NUREG-1910
Supplement 5

Environmental Impact Statement for the Ross ISR Project in Crook County, Wyoming

Final Report

Figure 3.16
Locations of 29 Water-Supply Wells
within a 3-Kilometer [2-Mile] Radius of Ross Project Area

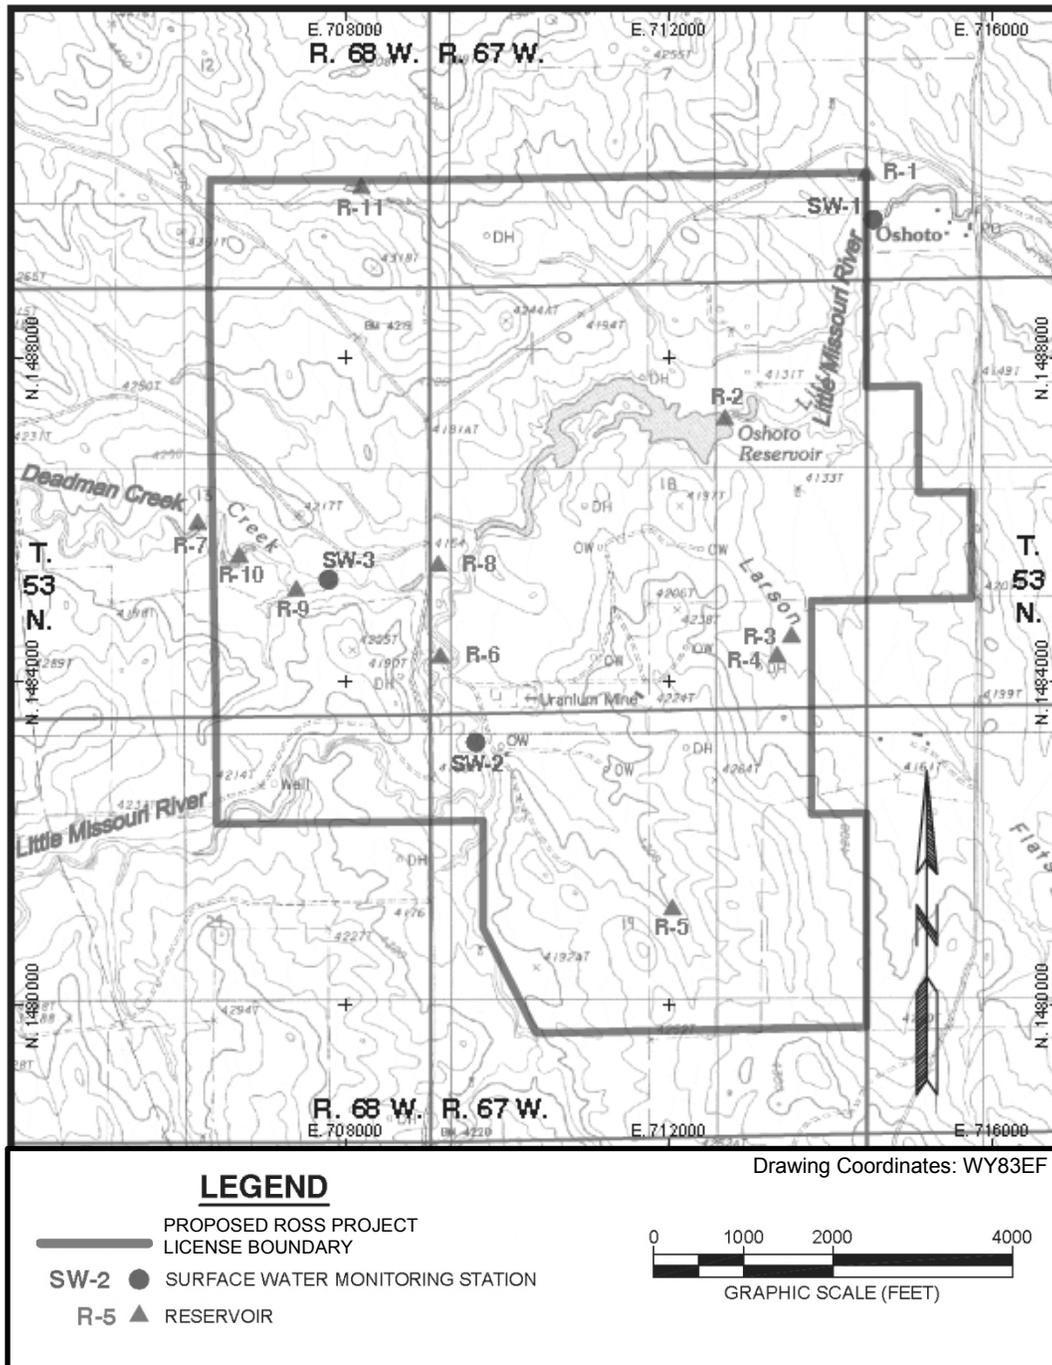
FSEIS SECTION	Page	Correction
3.5.3.3 Ground-Water Quality	3-38	Third full paragraph, lines 9 and 11, replace "Figure 3.14" with "Figure 3.15."
3.5.3.3 Ground-Water Quality	3-43	Figure 3.16, "Locations of 29 Water-Supply Wells within a 3-Kilometer [2-Mile] Radius of Ross Project Area," is the incorrect graphic. The graphic should be Environmental Report (ER) Figure 3.4-33, "Sampled Water Supply Wells," which can be found on ER Page 3-231 (ADAMS Accession No. ML110130342).
